USE PERMIT

10100 REISTERSTOWN ROAD
CURBSIDE PICKUP PLANS

CURBSIDE PICKUP PLAN

USE PERMIT

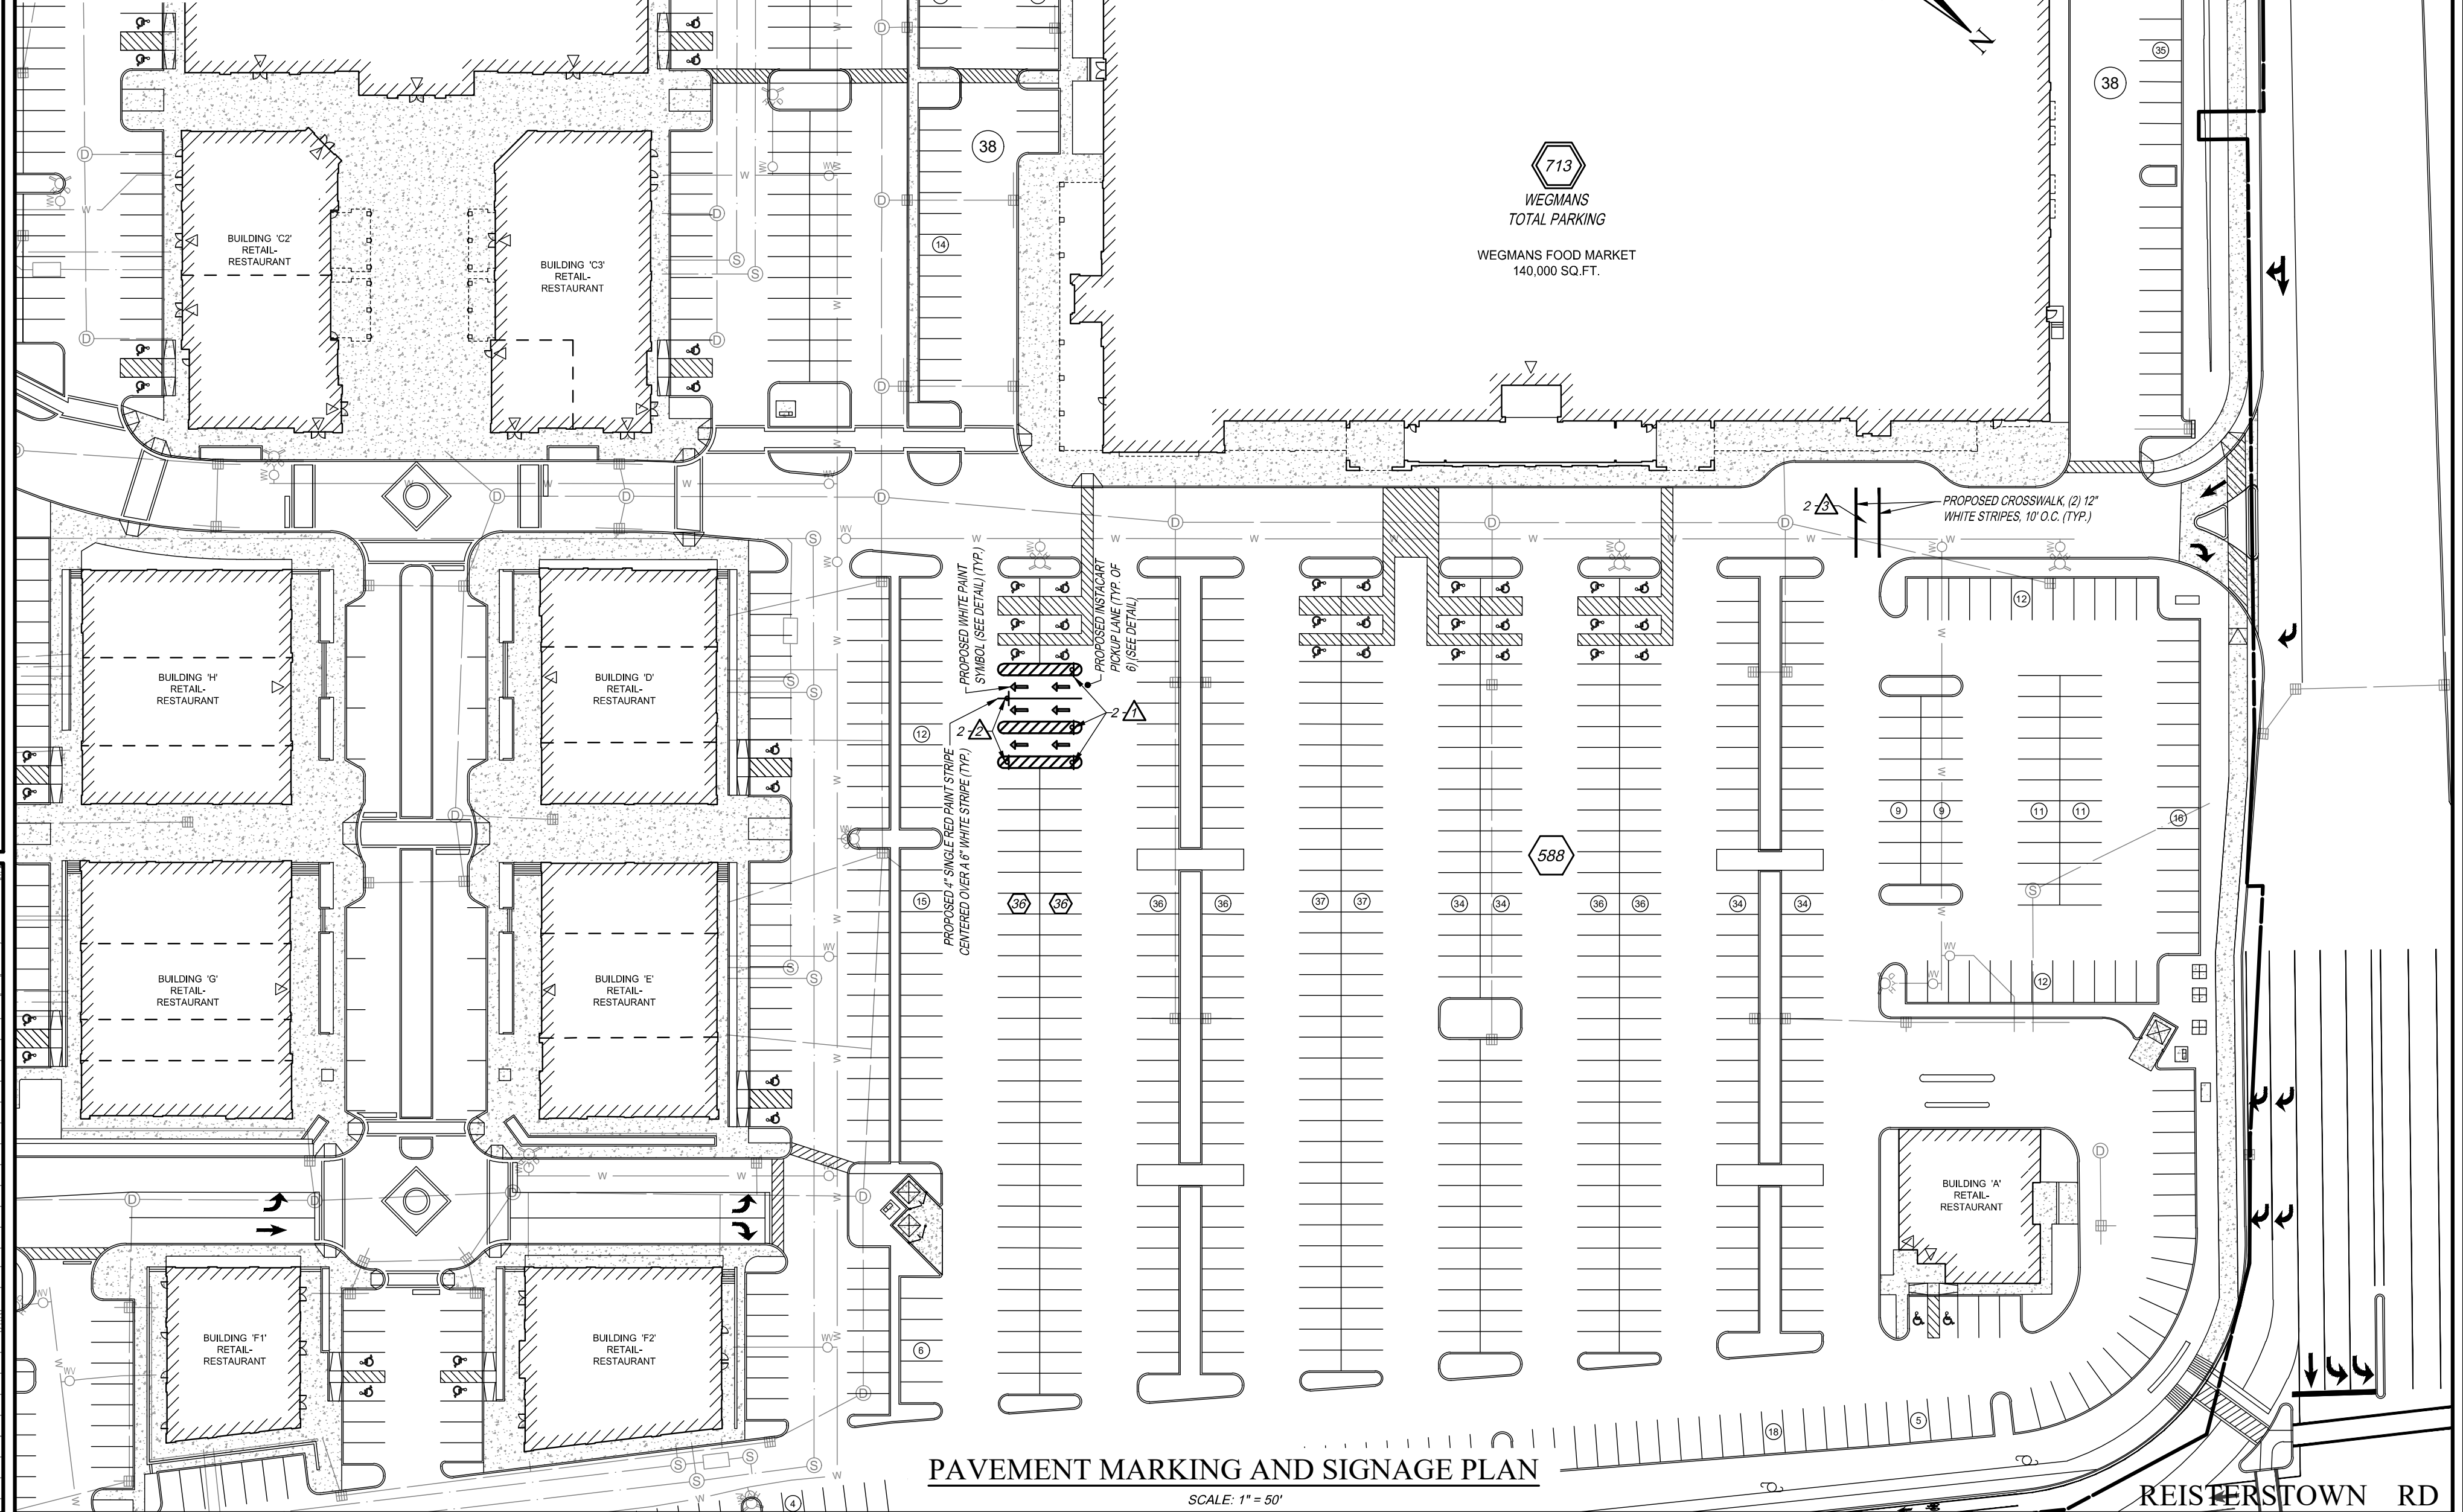
1				6/19/2024	PICKUP LANE REVISION	S.R.C.	D.E.L.	
NO.				DATE	REVISION	BY	CHKD.	APVLS.

PURPOSE:
1. ELIMINATION OF 18 STANDARD PARKING SPACES IN EXCHANGE FOR 6 LANES FOR CURBSIDE PICKUP.

TITLE OF PROJECT	WEGMANS FOOD MARKETS, INC. 10100 REISTERSTOWN ROAD
TITLE OF DRAWING	CURBSIDE PICKUP PLAN
LOCATION OF PROJECT	TOWN OF OWINGS MILLS COUNTY OF BALTIMORE, STATE OF MARYLAND
CLIENT	WEGMANS FOOD MARKETS, INC. 100 WEGMANS MARKET STREET ROCHESTER, NEW YORK 14624
DWG #	1858-125
SHEET	1 OF 1

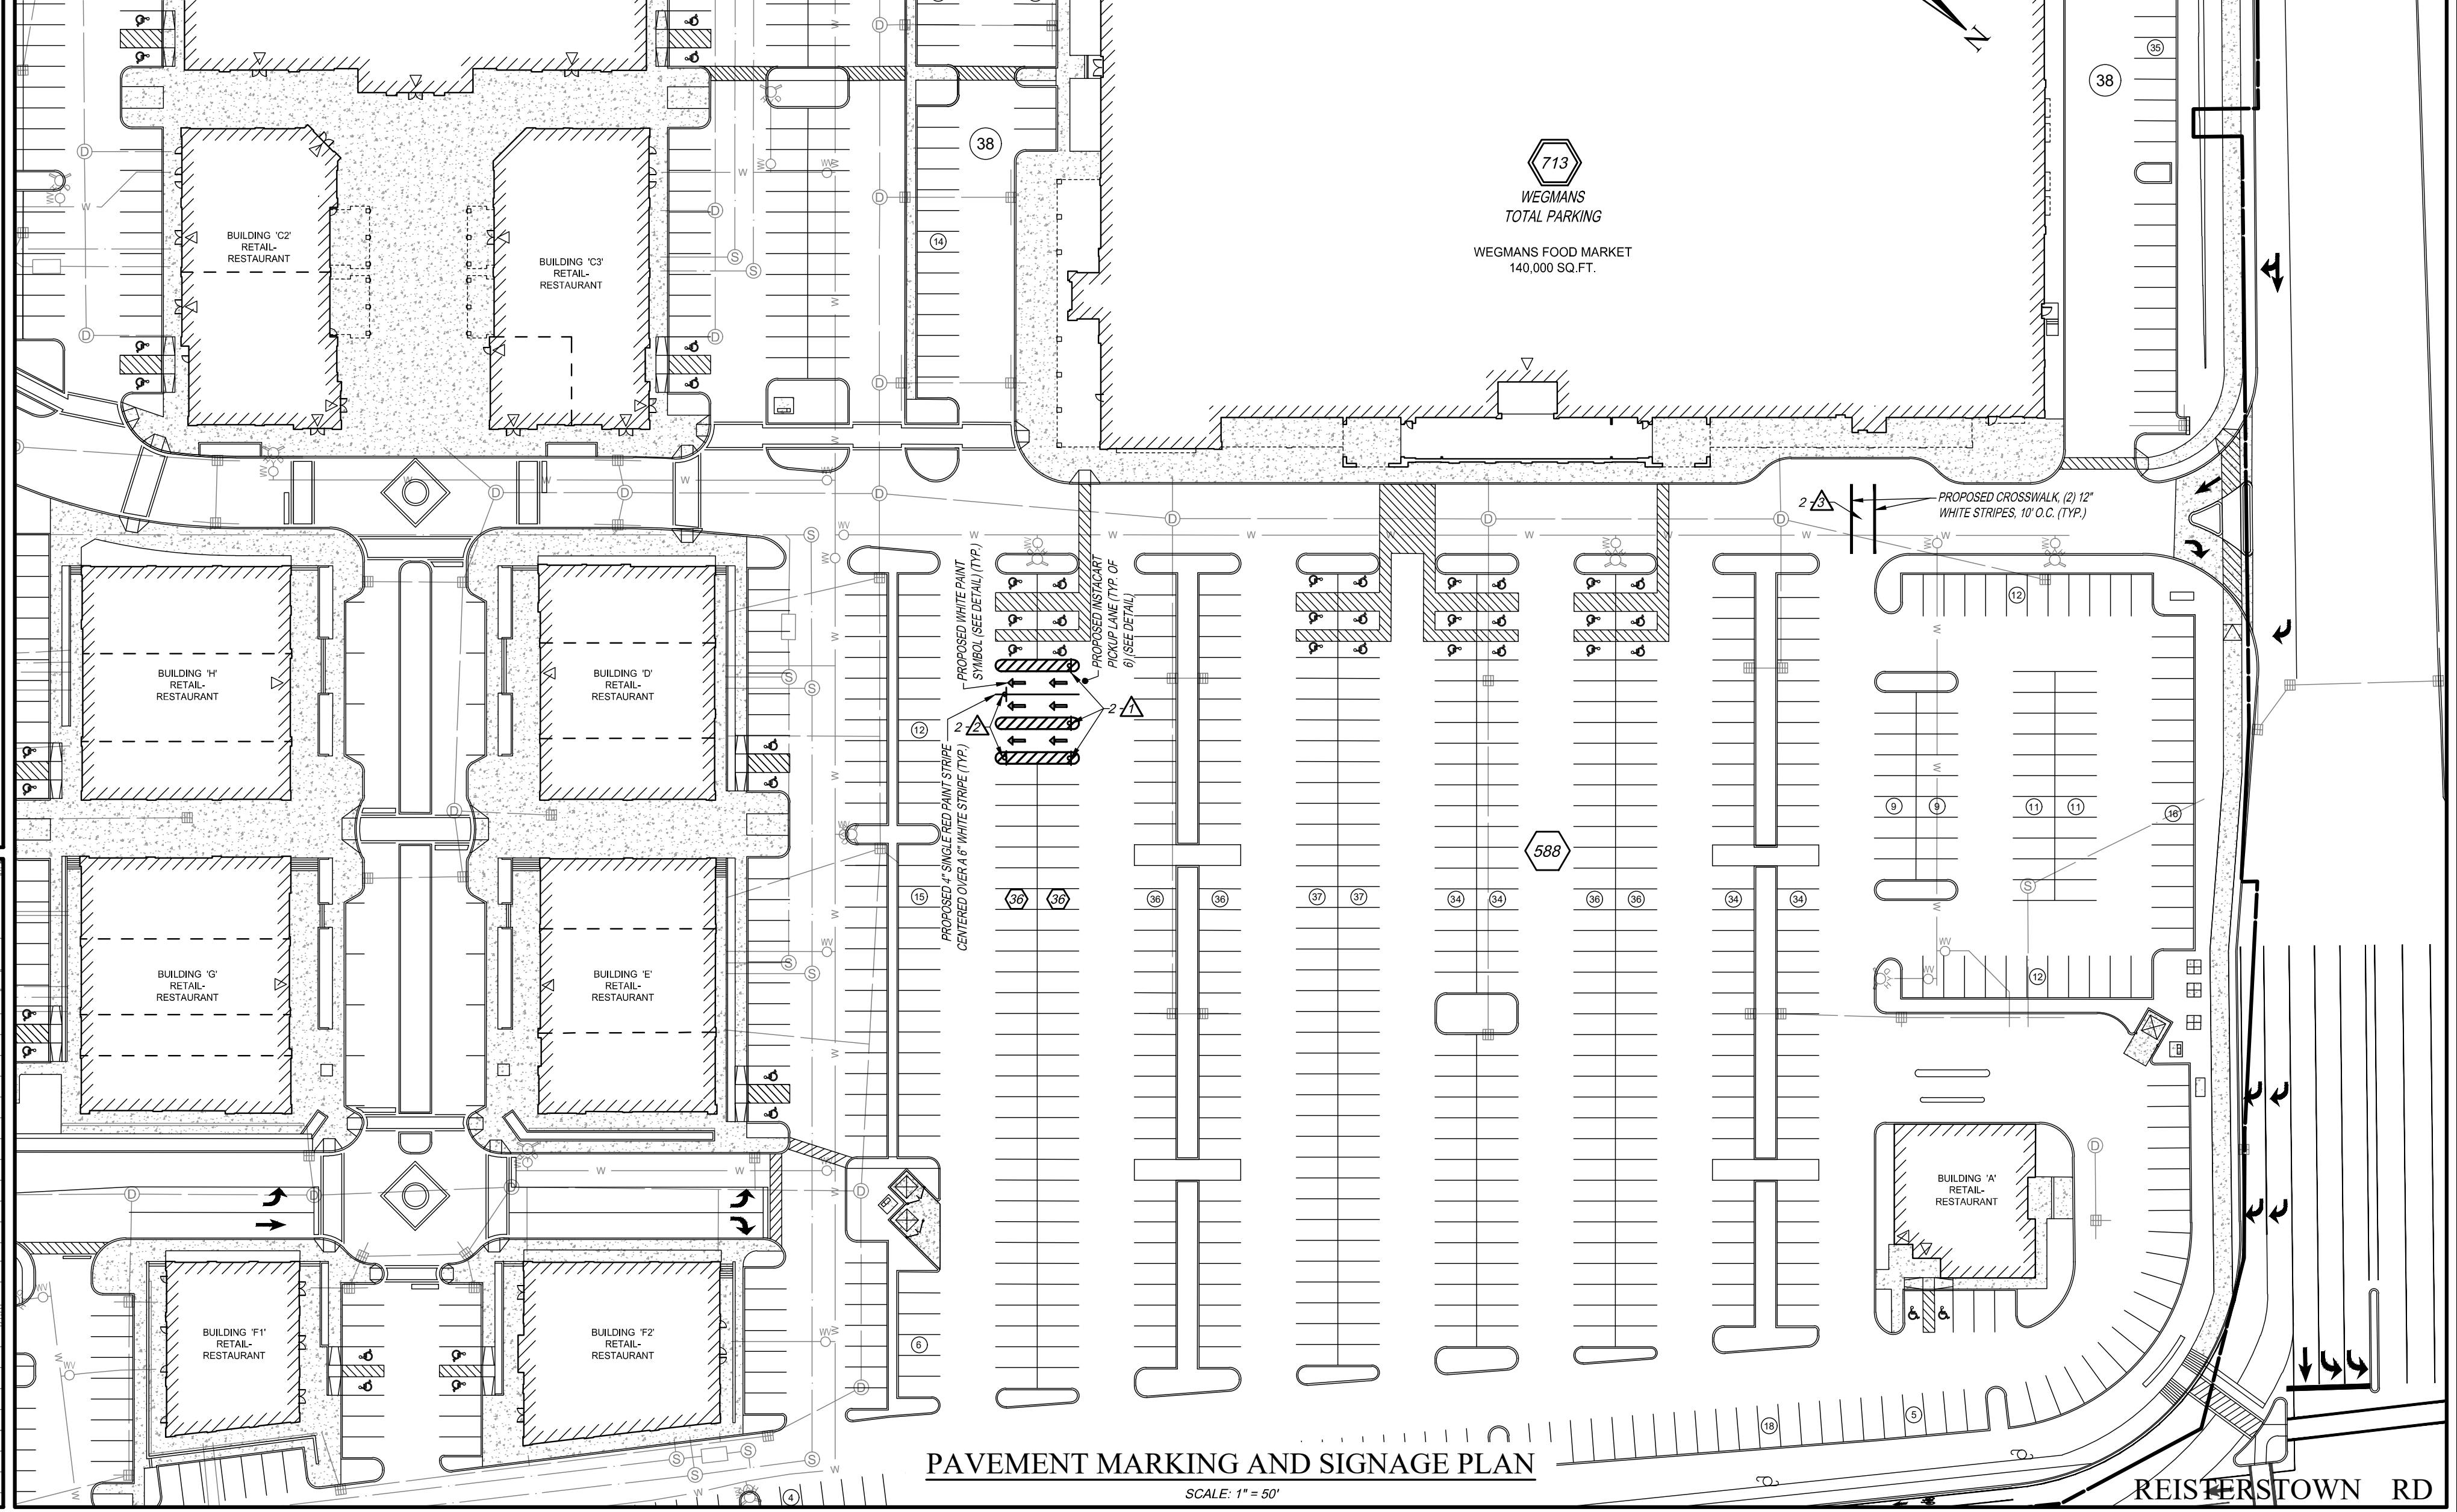
1	6/19/2024	PICKUP LANE REVISION	S.R.C.	D.E.L.	APVLS.
NO.	DATE	REVISION	BY	CHKD.	APVLS.

PURPOSE:
1. ELIMINATION OF 18 STANDARD PARKING SPACES IN EXCHANGE FOR 8 LANE FOR CURBSIDE PICKUP.
